The Commission has issued the enclosed Amendment No. 7 to Facility Operating License No. DPR-65 for the Millstone Nuclear Power Station, Unit 2. The amendment consists of changes to the Technical Specifications in response to your applications dated October 27, and December 11, 1975.

MILLSTONE NUCLEAR POWER STATION, UNIT 2

Amendment No. 7
License No. DPR-65

SAFETY EVALUATION BY THE OFFICE OF NUCLEAR REACTOR REGULATION
SUPPORTING AMENDMENT NO. 7 TO FACILITY OPERATING LICENSE NO. DPR-65

Figure 2.1-1 REACTOR CORE THERMAL MARGIN SAFETY LIMIT - FOUR REACTOR COOLANT PUMPS OPERATING

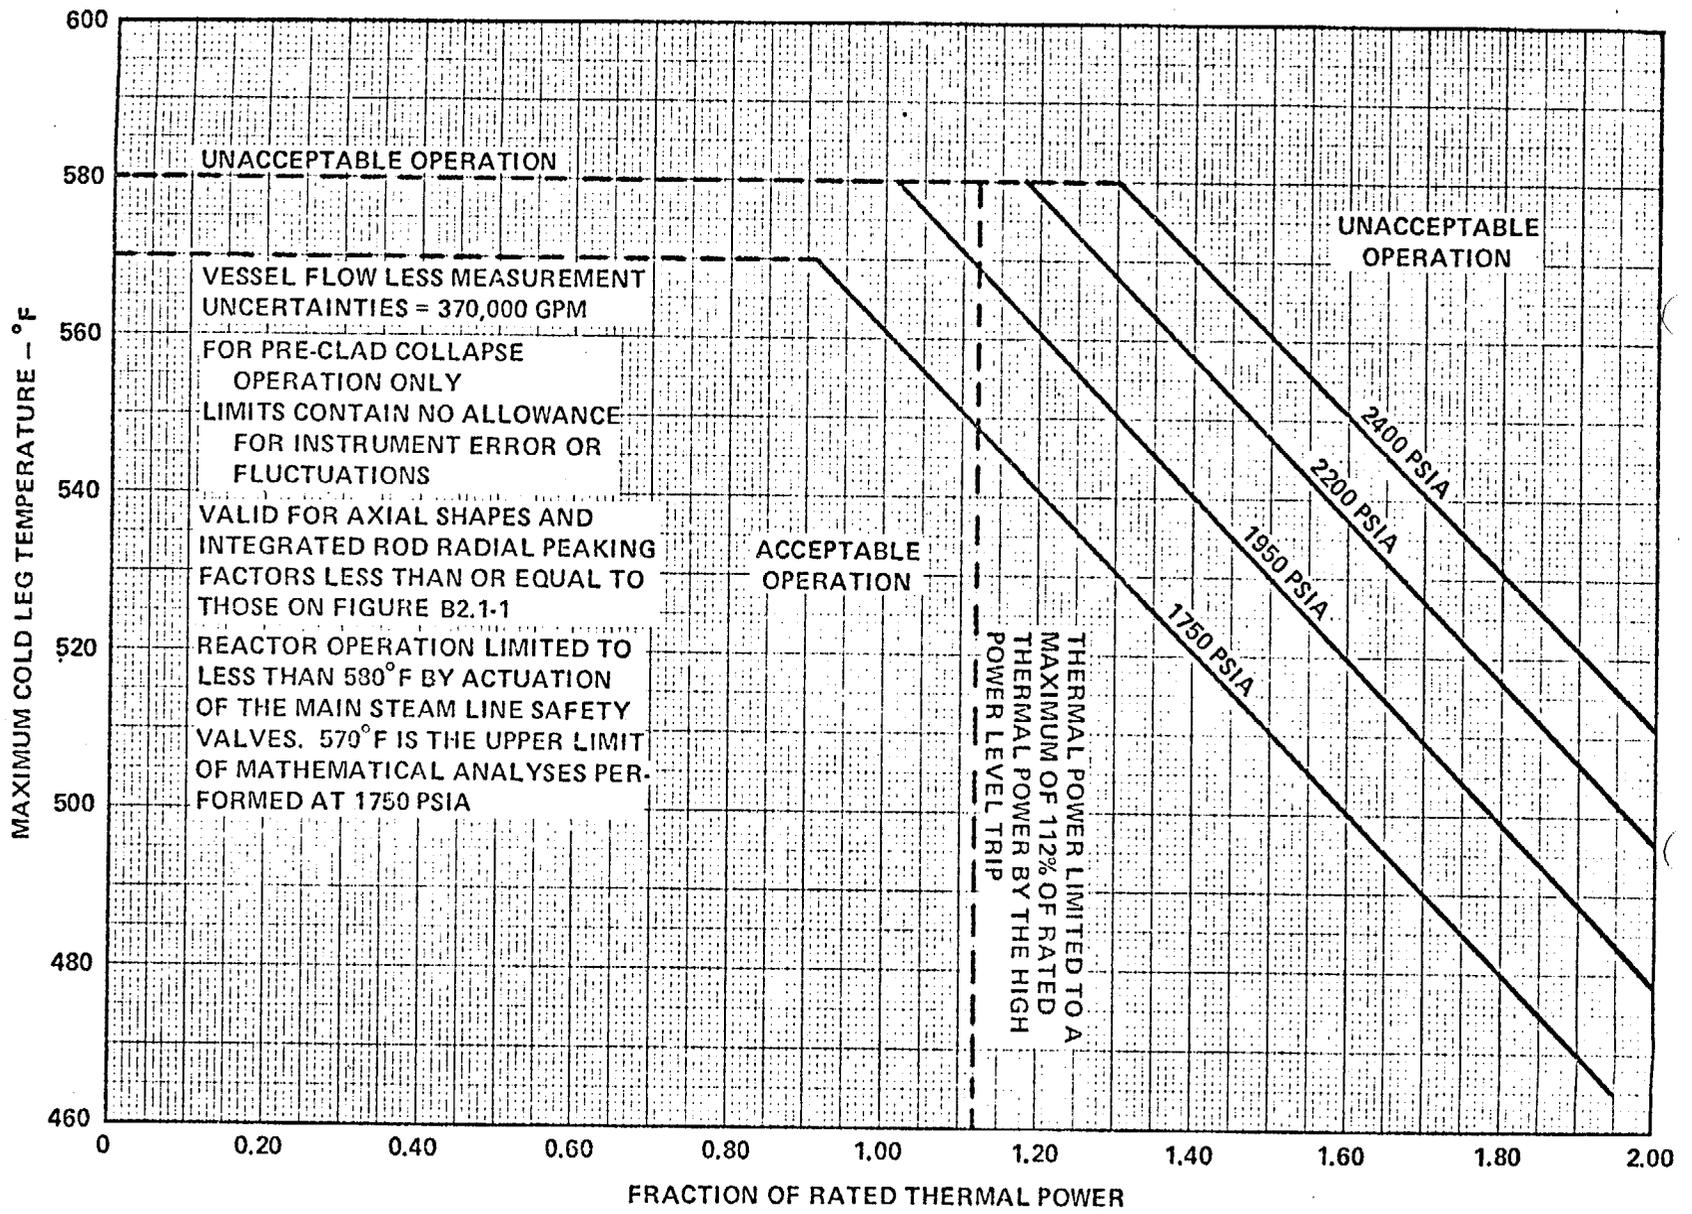
5. "Modify Figure 2.1-1, Reactor Core Thermal Margin Safety Limit, as follows:

- (a) Add a heavy dashed line across the 580°F line from zero power to the 2400 psia isobar.

- (b) Add a heavy dashed line across the 570°line from zero power to the 1750 psia isobar.

- (c) Add a heavy dash line vertically at 112 percent power from 460°F to 580°F.

- (d) Move the words "Acceptable Operation" to the left of the dashed vertical line at 112 percent power.

- (e) Add the following note vertically along the dashed 112 percent power line:

Thermal Power Limited to a Maximum of 112% of Rated Thermal Power by the High Power Level Trip.

- (f) Add the following note horizontally along the Fraction of Rated Thermal Power coordinate:

Reactor Operation Limited to Less than 580°F By Actuation of the Main Steam Line Safety Valve. 570°F is the Upper Limit of Mathematical Analyses Performed at 1750 psia.

- (g) Change in associated Technical Specification Bases to reflect the above changes."

Figure 2.1-1 represents the Reactor Core Thermal Margin Safety Limit. The proposed changes do not alter any of these operating limits but supply additional information on related reactor operational limitations. This proposed change has no safety significance and is acceptable.

FIGURE 3.2-4

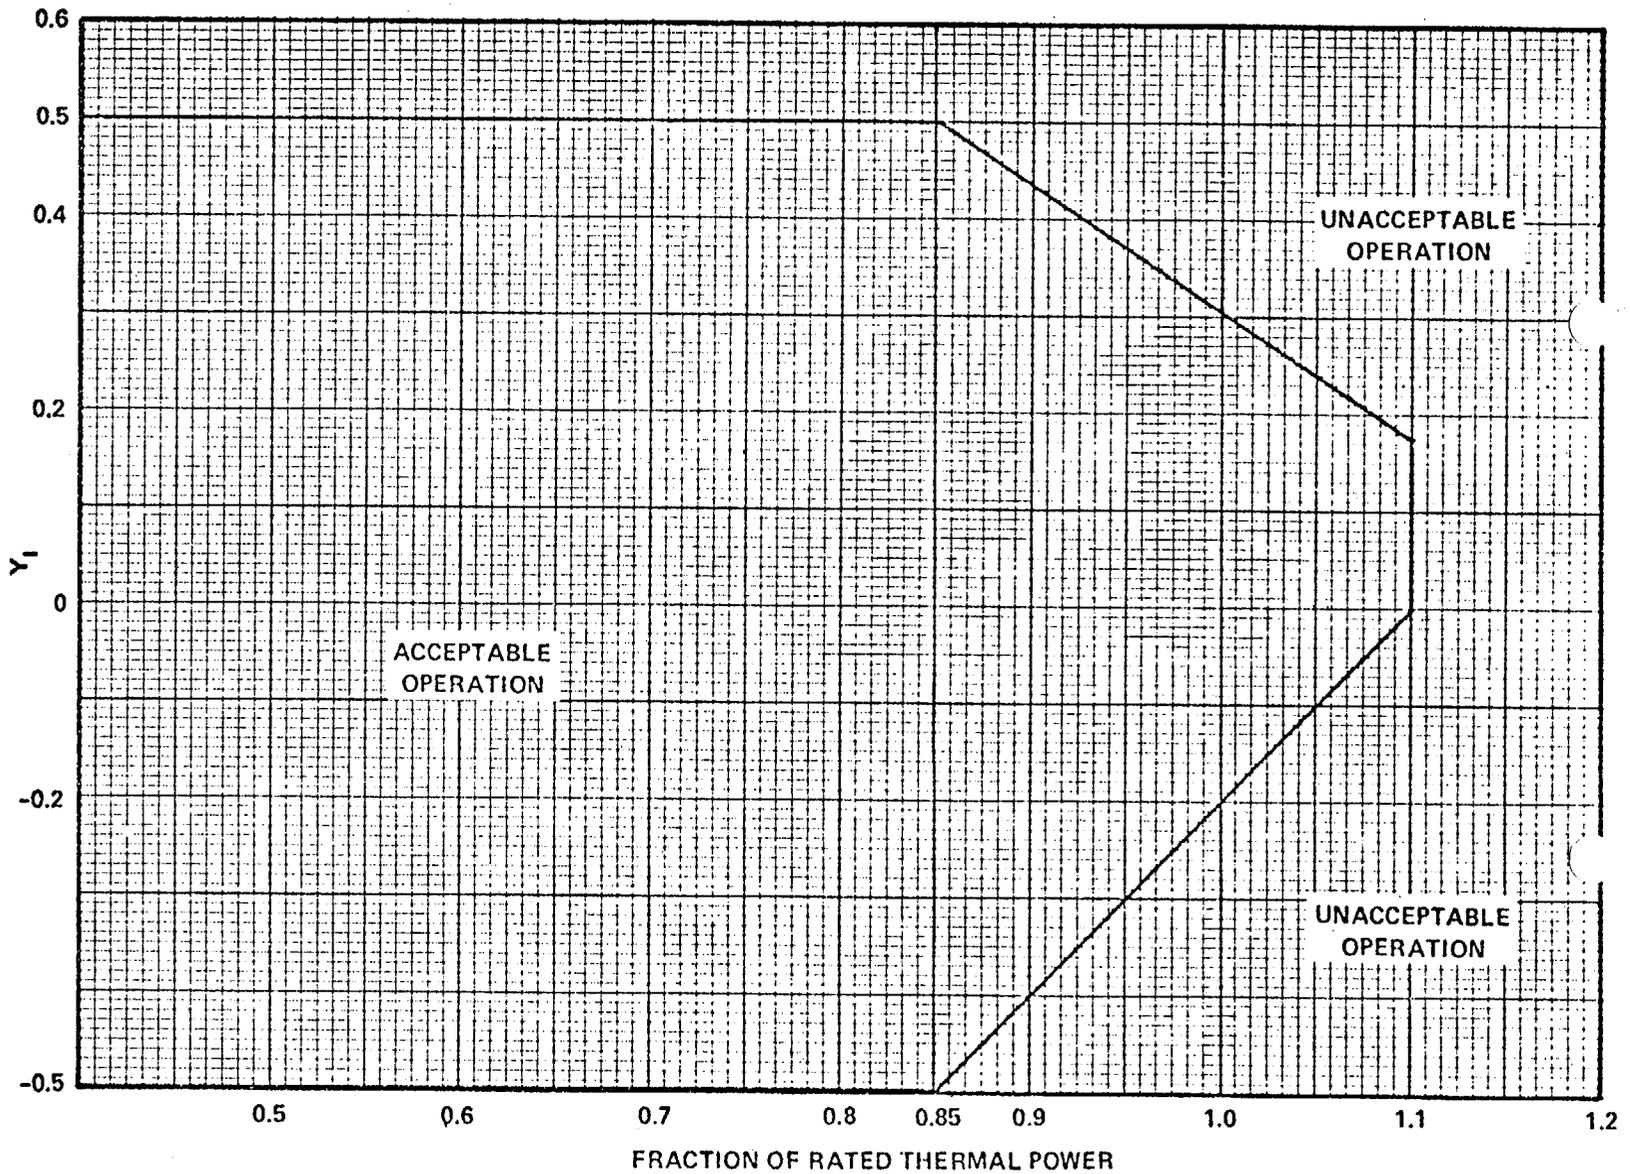
1. "Modify Figure 3.2-4, page 3/4 2-14, by deleting the notations Q_1 and Q_2 and the dashed vertical lines at 85 and 100 percent power."

Figure 3.2-4 is a plot of Axial Shape Index as a function of Rated Thermal Power. The two vertical broken lines, appearing at .85 and 1.0 Thermal Power and labeled Q_1 and Q_2 , respectively, are not referenced elsewhere in the Technical Specifications and have no significance with regard to Technical Specification 3.2.5 or 4.2.5 which reference Figure 3.2-4. Therefore, deletion of the broken lines and their associated labels Q_1 and Q_2 has no safety significance and is acceptable.
